SWIM PROJECT PROFILE		Pilo No. : 166
Regist. No. : Agency No. : BSWM-80	Name: CAMBURAY SWIP	
Region: 4	Province: OCCIDENTAL MINDORO	Municipality: SAN JOSE
Present Status: 1. Pro-F/S() ② F/S(1985) ③ D/D(1985)		
Purpose: Major : Irrigation Incidental : IF, FC, WM		
Project Feature:

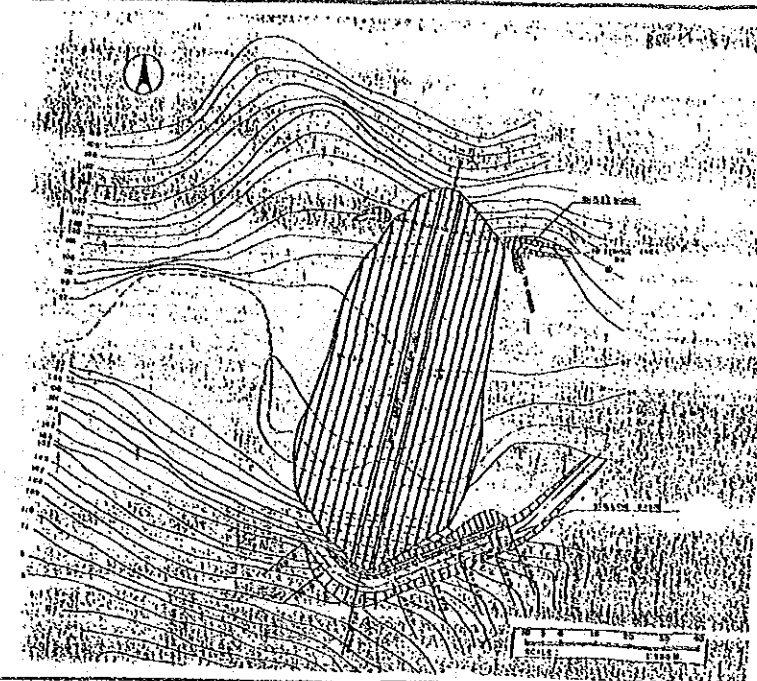
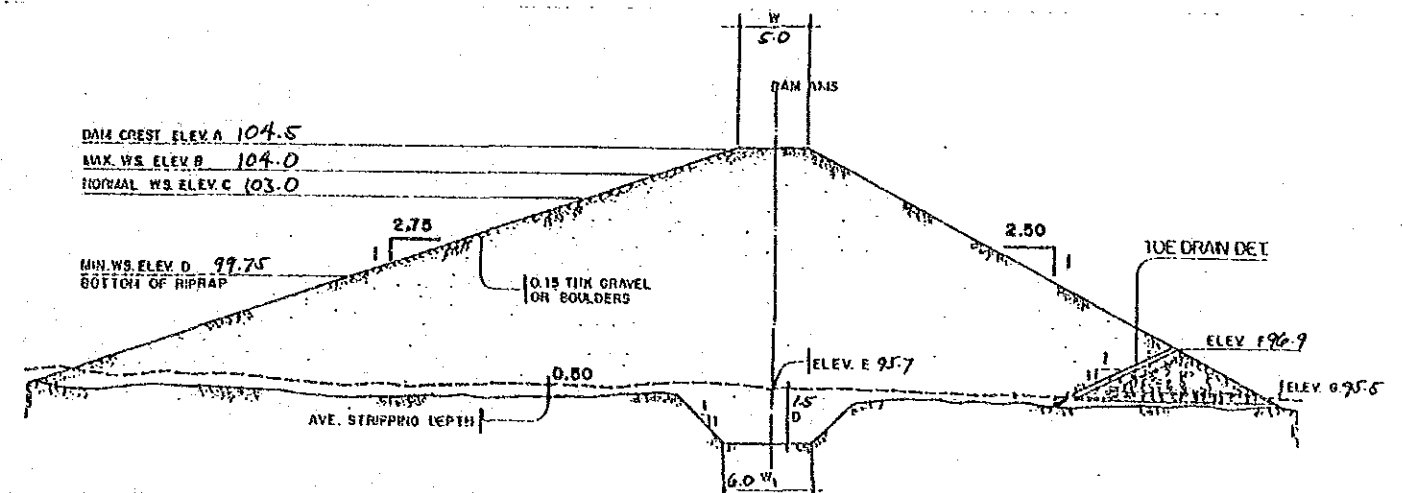
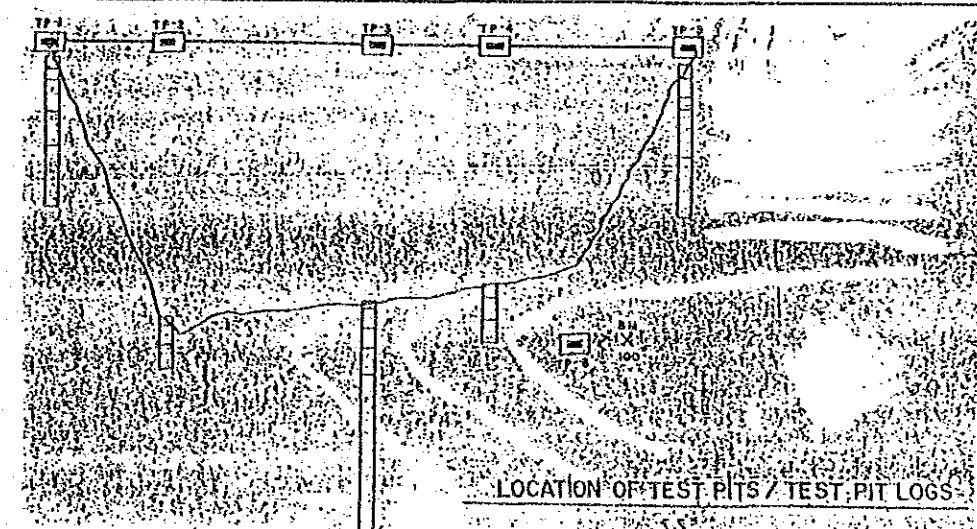
2. Planning		
Environmental conservation plan is not formulated.		
3. Design		
Depth of core trench shall be modified during construction.		
Stability of upstream slope of the dam shall be checked.		
Freeboard is not enough.		
Center line of the spillway shall be shifted to left side.		
Weir shall be provided in the spillway.

Note: Silty clay with 3.0 m depth is piled up on the Basalt and Andesite. Additional 0.5 m freeboard is necessary.

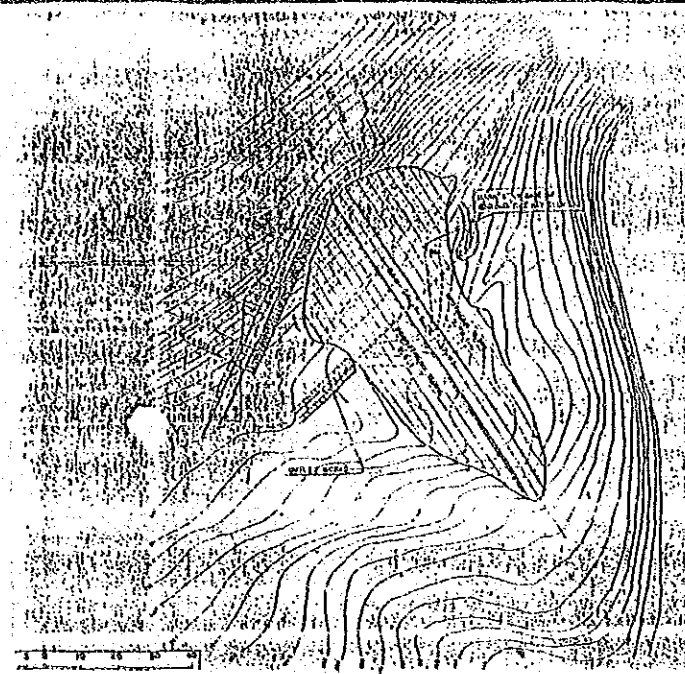
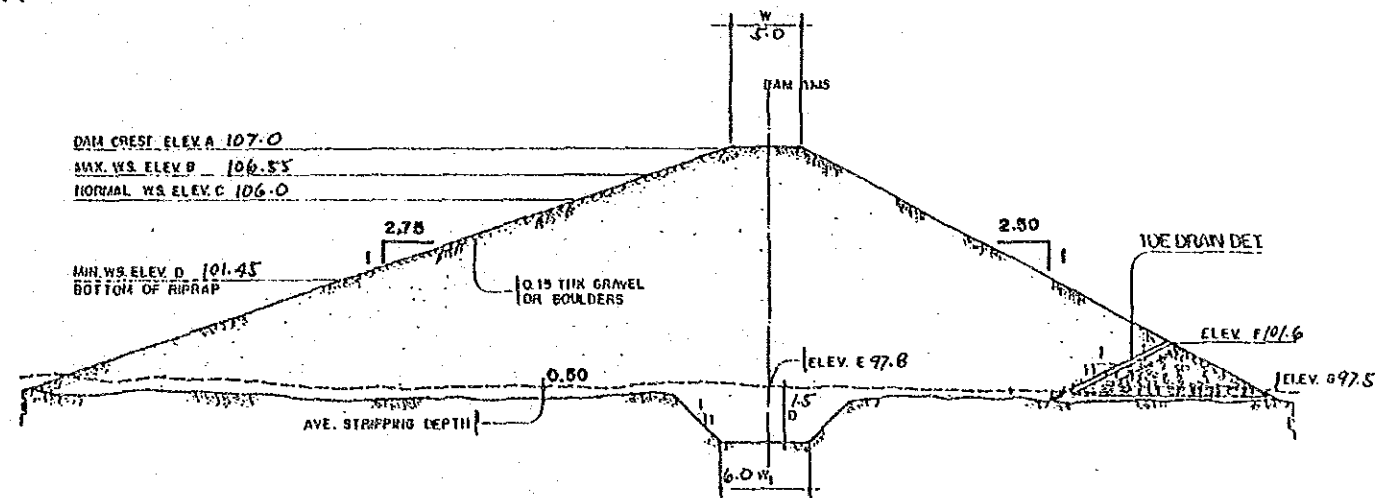
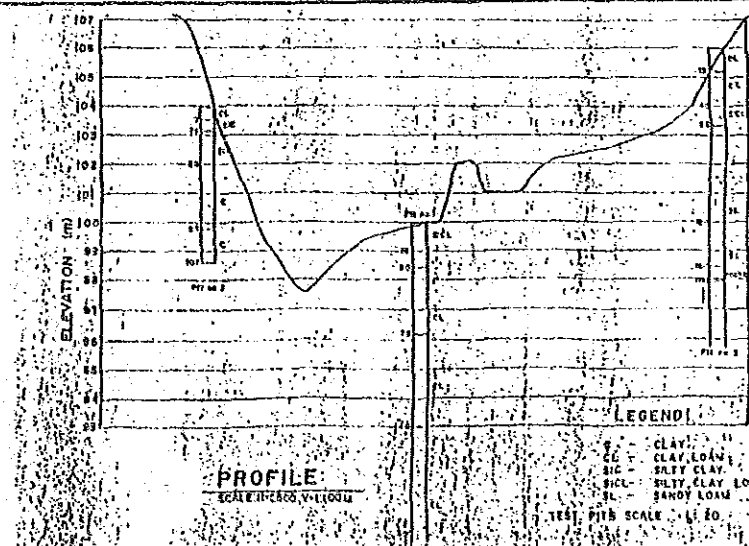
2. Planning		
Environmental conservation plan is not formulated.		
3. Design		
Depth of core trench shall be modified during construction.		
Stability of upstream slope of the dam shall be checked.		
Freeboard is not enough.		
Weir shall be provided in the spillway.

Note: Clay with 1.0-3.0 m depth is piled up on the shale. Additional 1.0 m freeboard is necessary.

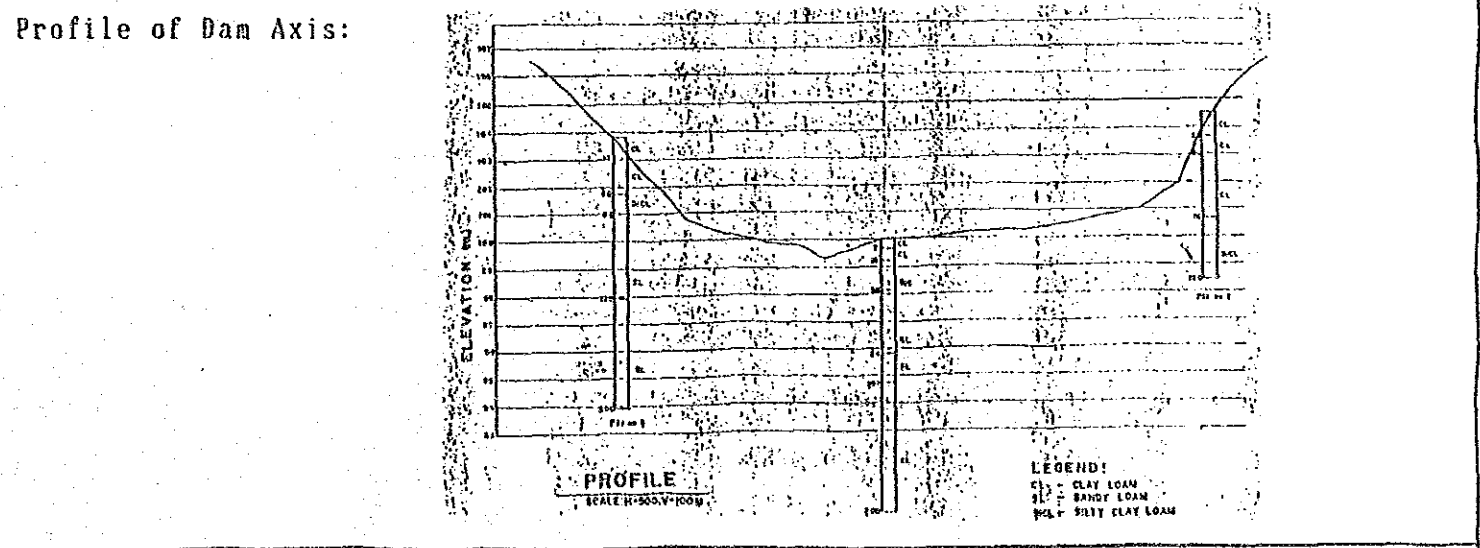
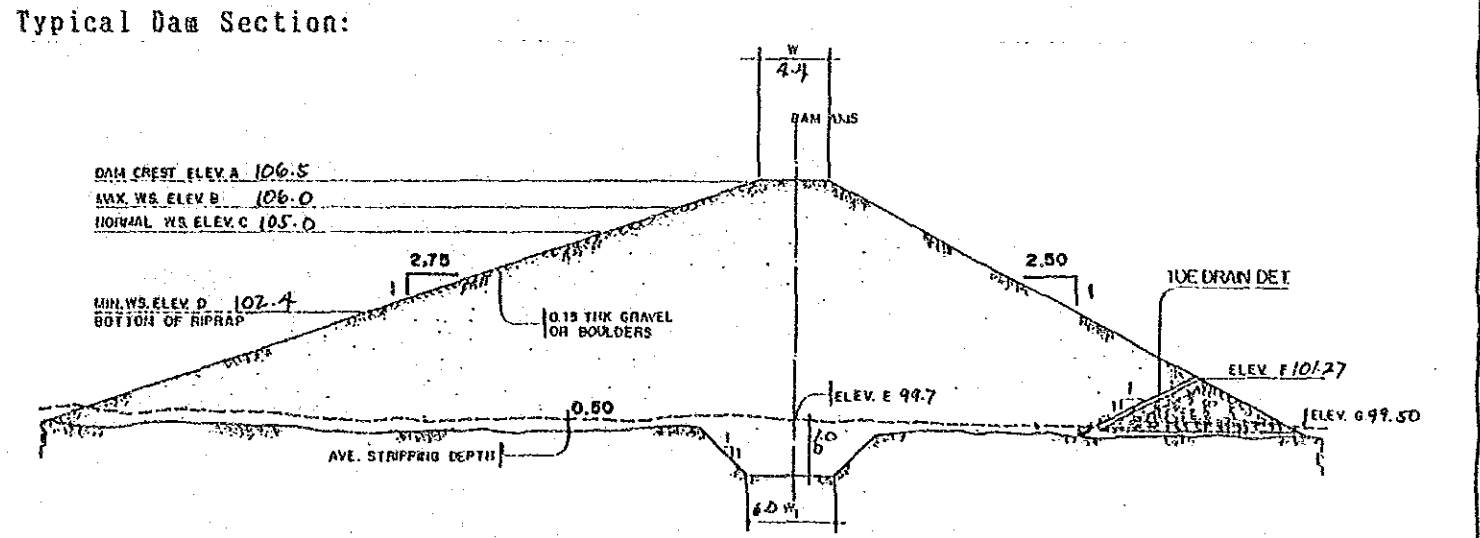
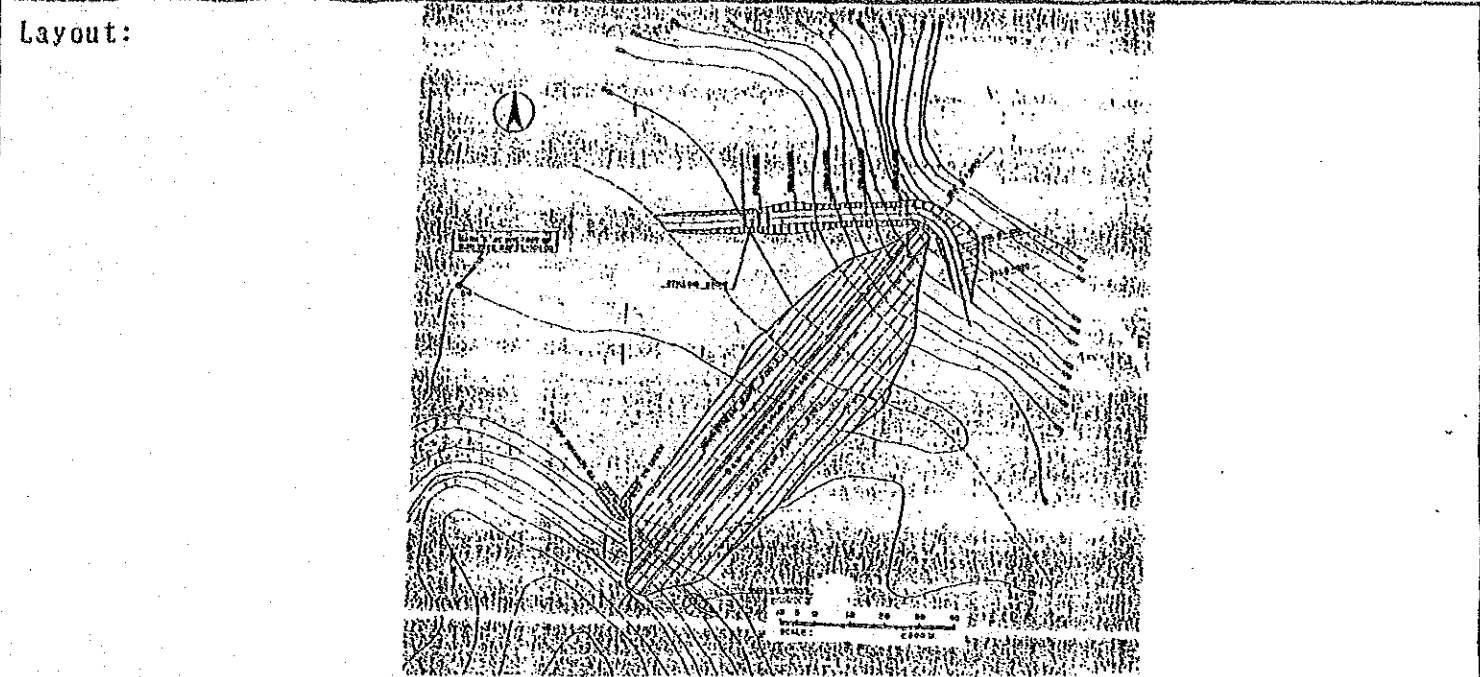
2. Planning Environmental conservation plan is not formulated.		
3. Design Depth of core trench shall be modified during construction. Stability of upstream slope of the dam shall be checked. Freeboard is not enough. Weir shall be provided in the spillway.

Note: Clay with 2.0 m depth is piled up on the dacite and andesite. Additional 0.5 m freeboard is necessary.

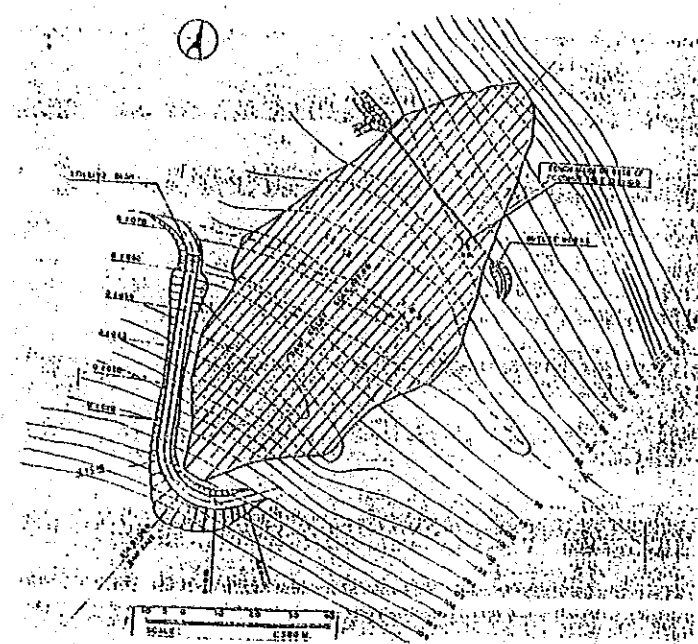
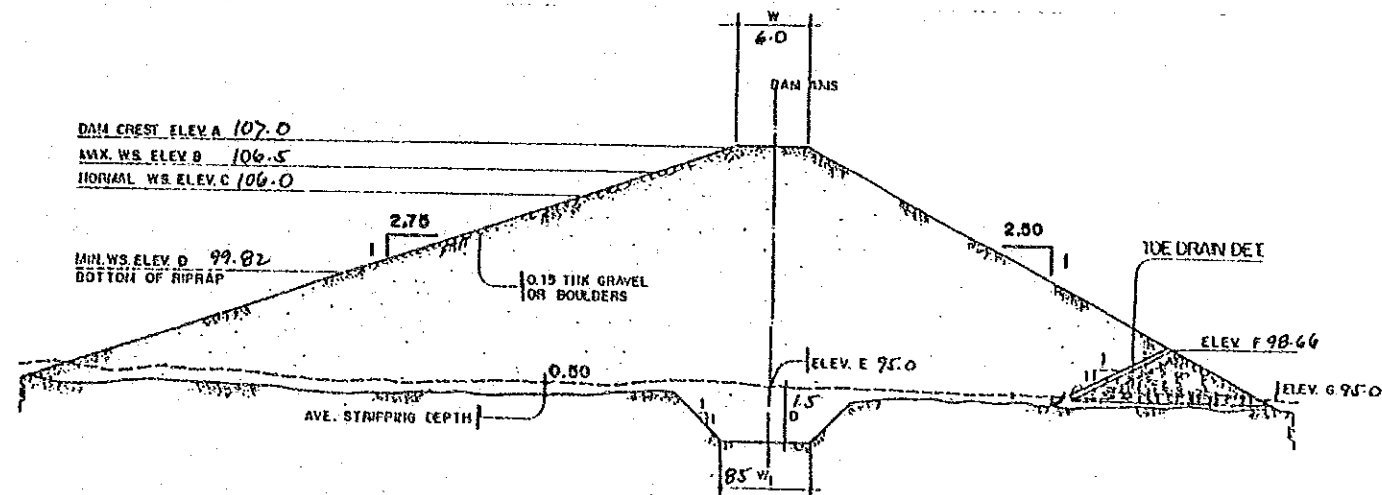
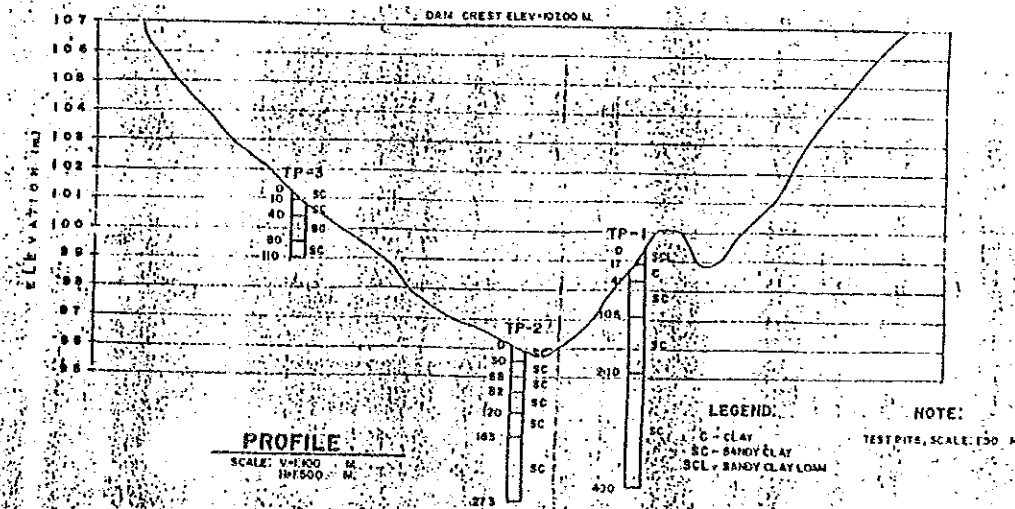
2. Planning Environmental conservation plan is not formulated.		
3. Design Depth of core trench shall be modified during construction. Stability of upstream slope of the dam shall be checked. Weir shall be provided in the spillway.

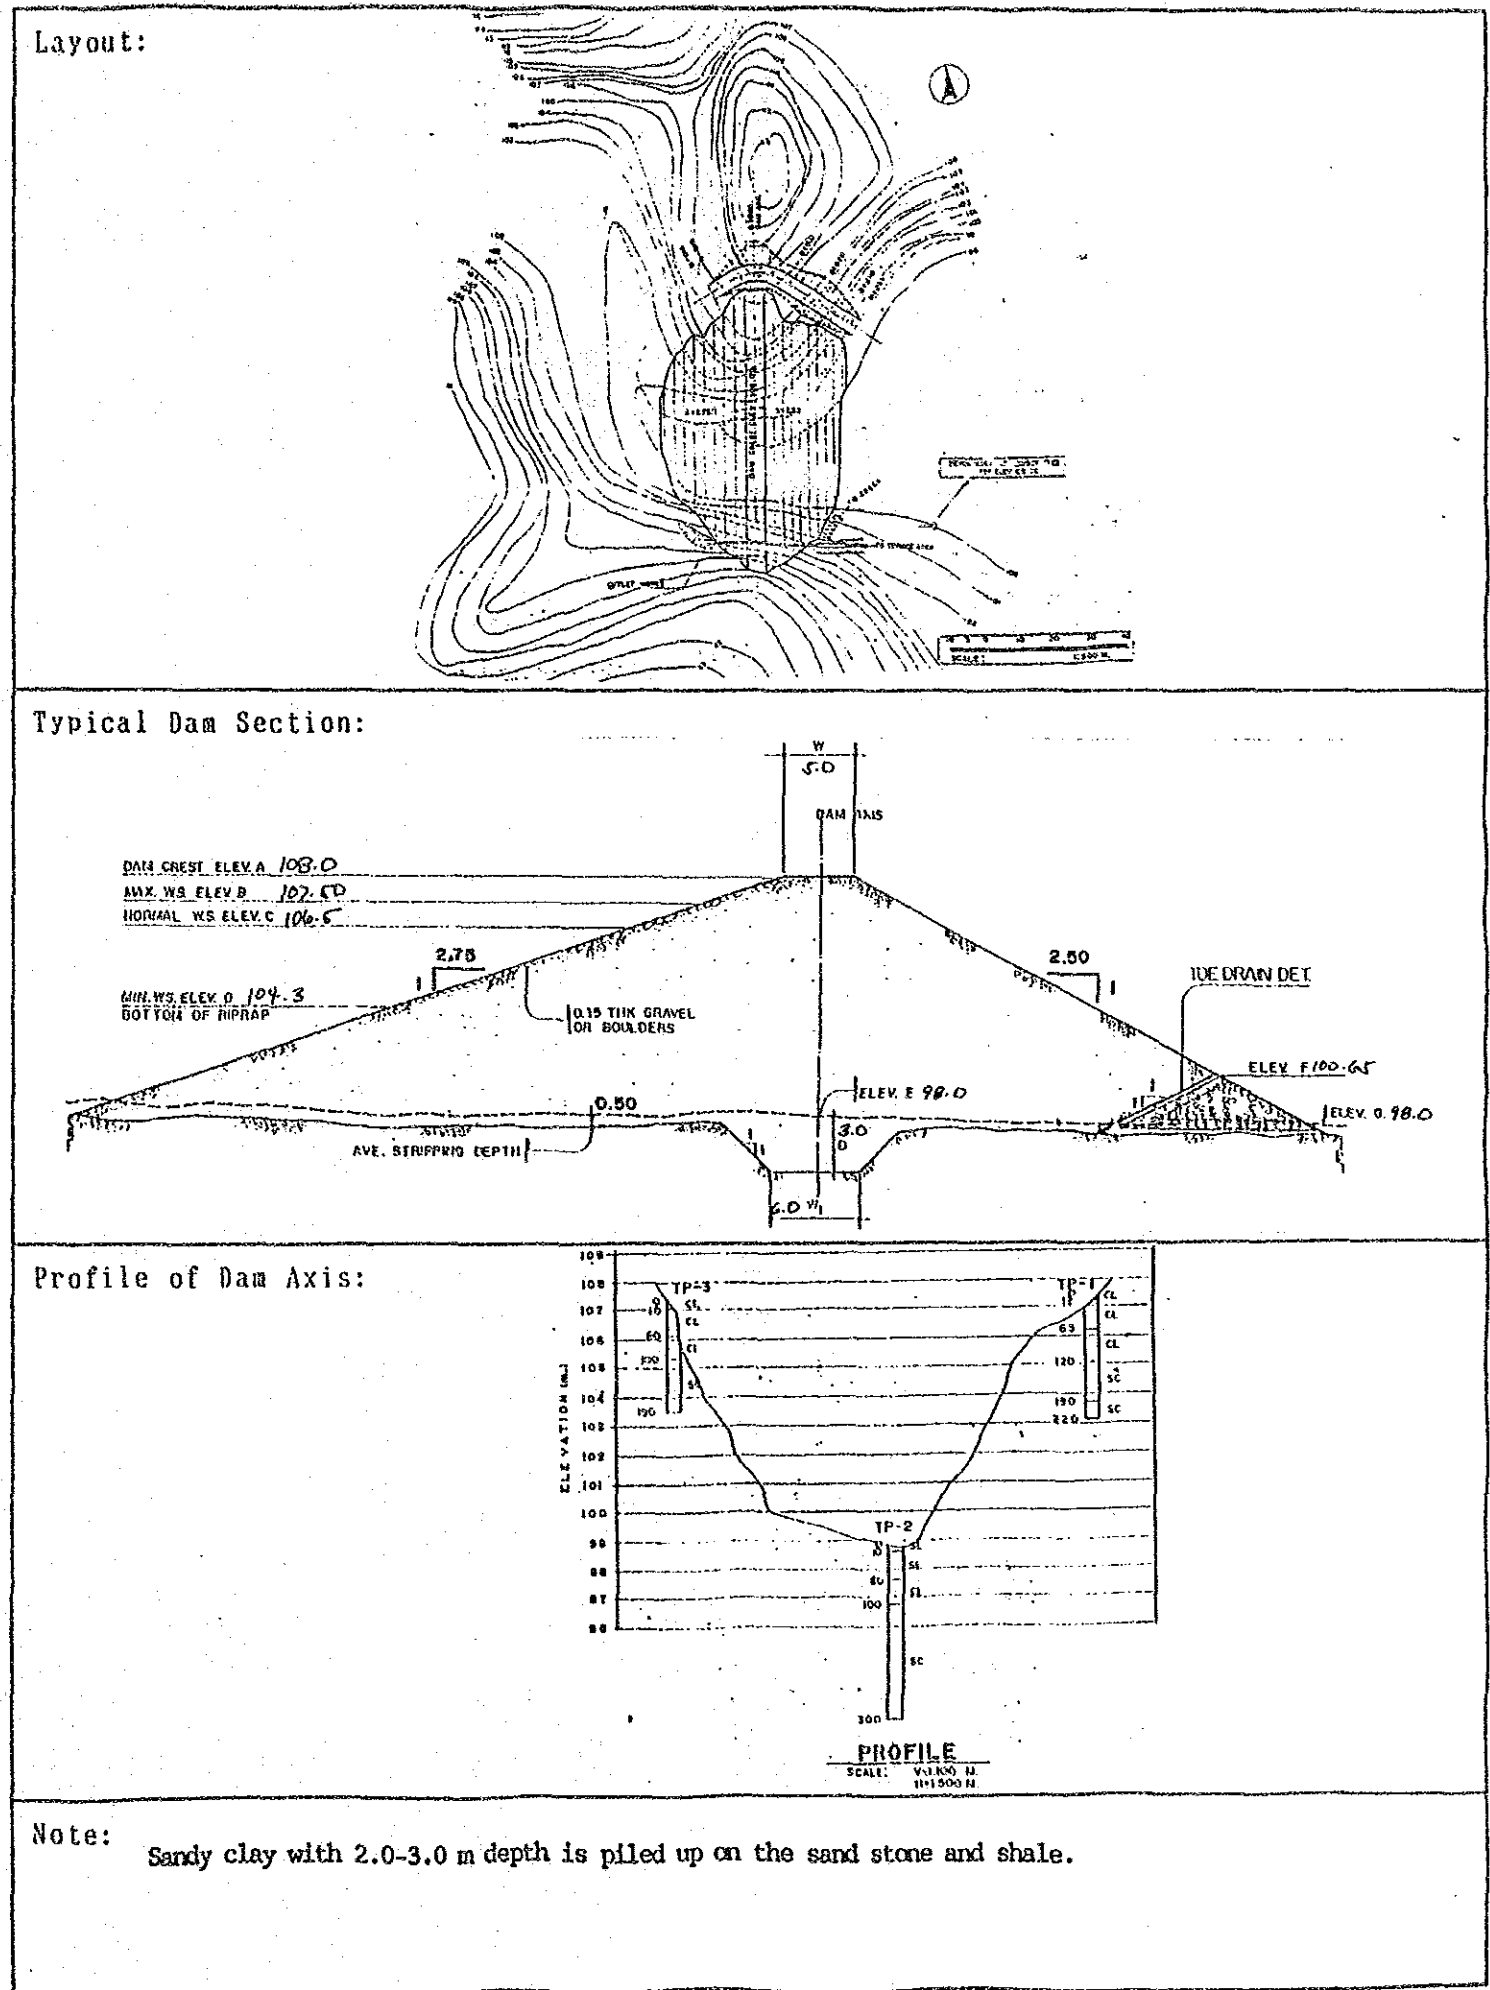
2. Planning Environmental conservation plan is not formulated.		
3. Design Depth of core trench shall be modified during construction. Stability of upstream slope of the dam shall be checked. Center line of the spillway shall be shifted to left side. Weir shall be provided in the spillway.
